Hope Creek Generating Station
Facility Operating License No. NPF-57
NRC Docket No. 50-354

Subject: Responses to Requests for Additional Information
Request for License Amendment - Extended Power Uprate

Extended Power Uprate

Response to Request for Additional Information

RAI 14.116(c) Follow-Up

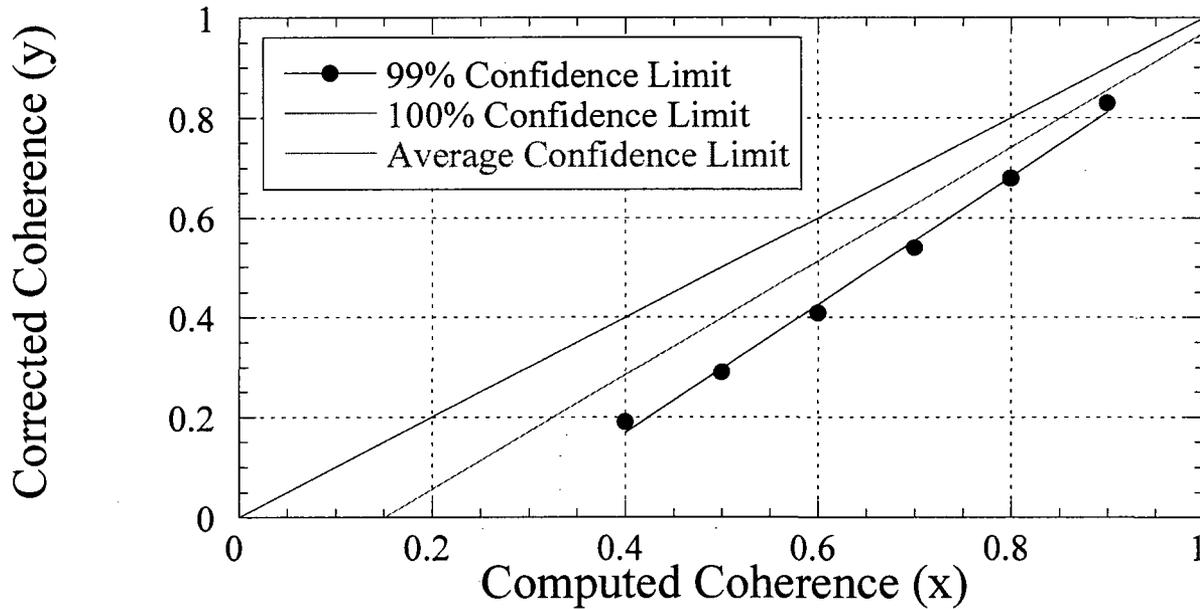
The PSEG response does not provide the basis for correcting the coherence between **[[**

The reference J. S. Bendat and A. G. Piersol, 1966, Measurement and Analysis of Random Data, John Wiley and Sons, Page 215, Table 5.1 (described in C.D.I. Report No. 07-09P) gives 99% confidence limits on the coherence based on coherence estimates, as provided in our previous response to this RAI:

Coherence Estimate	Lower Confidence Limits
0.4	0.19
0.5	0.29
0.6	0.41
0.7	0.54
0.8	0.68
0.9	0.83

A plot of these data gives the following:

where a linear curve fit through the data points (black circles) gives the line $y = -0.346 + 1.286x$ ($R^2 = 0.995$) in black, the one-to-one curve (no correction) in blue, and the line halfway between the linear curve fit and no correction (halfway to the lower confidence limits, identified in the figure as the average confidence limit) in red. The average confidence limit recovers a corrected coherence that is more conservative (a higher value) than use of the 99% confidence limit as suggested in the data of Bendat and Piersol, as it follows from the equation $y = -0.173 + 1.143x$. For example, if the computed coherence between the upper and lower strain gage measurements is 0.6, no correction would leave the coherence at 0.6, use of the 99% confidence limit curve would give a corrected coherence of 0.4, while an average coherence value would give 0.5. The average values are used in the analysis.
